AGENDA OF THE REGULAR MEETING OF THE CITY COUNCIL CITY OF BIRCHWOOD VILLAGE WASHINGTON COUNTY, MINNESOTA August 10, 2021 7:00 P.M.

- A. Variance Case No. 21-03-VB for 143 Wildwood Avenue* (pp. 23-92)
 - a. Council Deliberation

- 3. AGENDA ITEM A Variance Case No 21-03-VB 143 Wildwood Ave
 - a. Public Hearing
 - i. Property owner Cameron Sigecan was present to discuss the newly revised and submitted variance application 21-03-143, architectural renderings, supporting information

MANAGEMENT AND MAINTENANCE PLAN

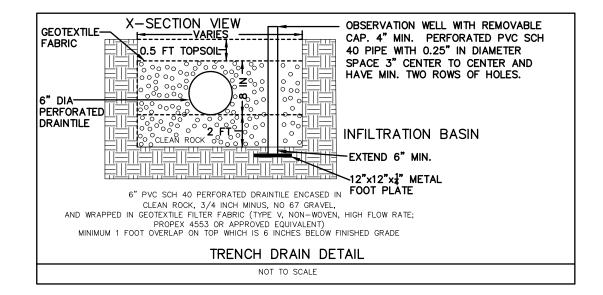
- One concern with infiltration in cold weather is the ice that forms both over the top of the practice and within the soil structure, which can completely stop infiltration. To limit the effect of this problem, it is HIGHLY RECOMMENDED that the BMP be actively inspected to ensure that it is properly drawing down before it freezes in the late fall. Adequate drawdown can be determined using one of the several field assessment techniques such as those recommended by the University of Minnesota Extension. If it is determined that stormwater runoff is not infiltrating prior to hard freeze, the BMP should be placed offline for correction in the spring.

- <u>Item i.:</u> Information regarding the stormwater management plan and shall include the applicant's description of how the practices shall be maintained to function as designed for the long-term.

- <u>Item j.:</u> Information regarding the maintenance plan and a maintenance schedule for the stormwater management practices.

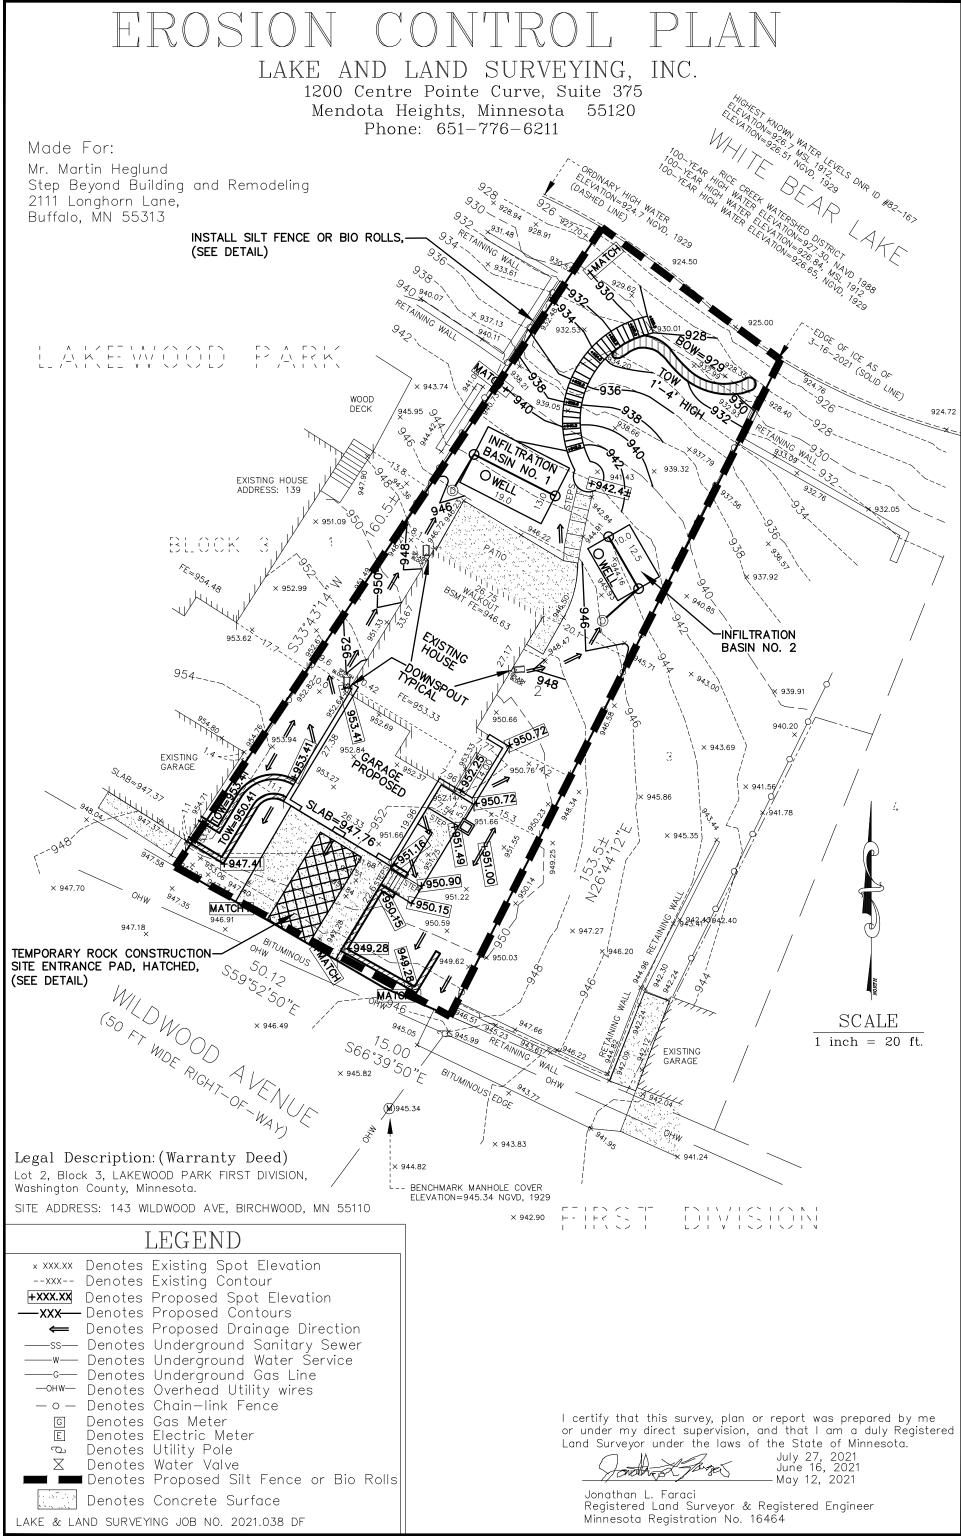
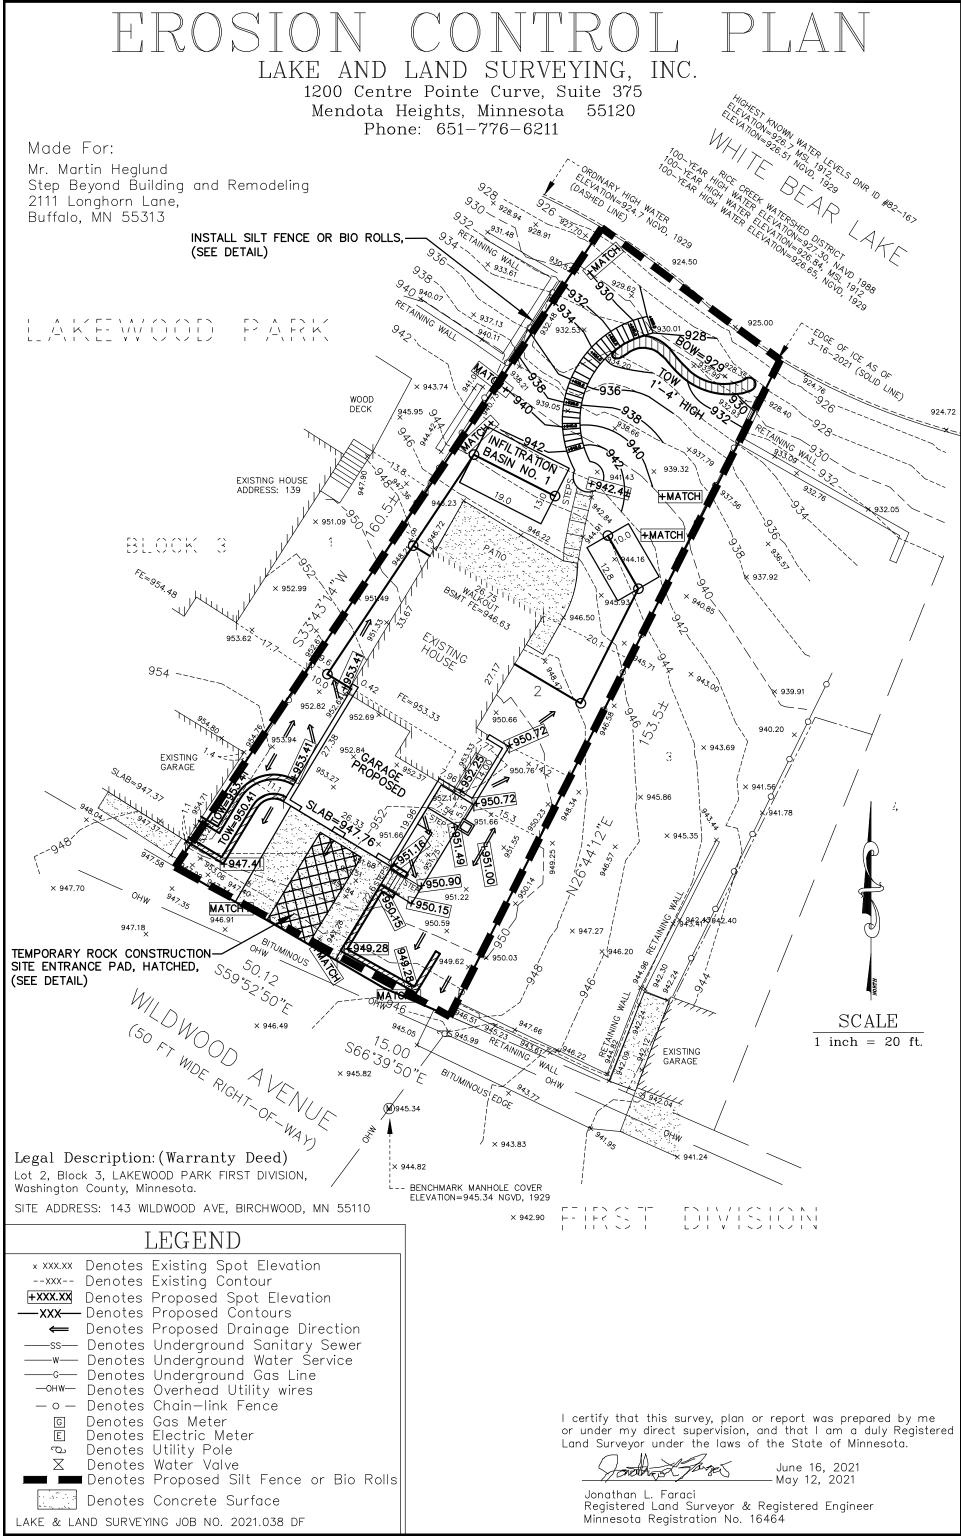
The Site Plan prepared by Lake and Land Surveying, Inc. dated June 16, 2021 shows a boulder retaining wall within 50 feet of the OHWL of White Bear Lake. Thus, a variance from the setback requirement is needed if a boulder retaining wall is proposed within 50 feet of the OHWL.

The Site Plan prepared by Lake and Land Surveying, Inc. dated June 16, 2021 shows grading within 20 feet of the OHWL of White Bear Lake. Thus, a variance from the no grading requirement is needed if grading is proposed within 20 feet of the OHWL.

The Site Plan prepared by Lake and Land Surveying, Inc. dated June 16, 2021 shows a boulder retaining wall within 50 feet of the OHWL of White Bear Lake. Thus, a variance from the setback requirement is needed if a boulder retaining wall is proposed within 50 feet of the OHWL.

The Site Plan prepared by Lake and Land Surveying, Inc. dated June 16, 2021 shows grading within 20 feet of the OHWL of White Bear Lake. Thus, a variance from the no grading requirement is needed if grading is proposed within 20 feet of the OHWL.
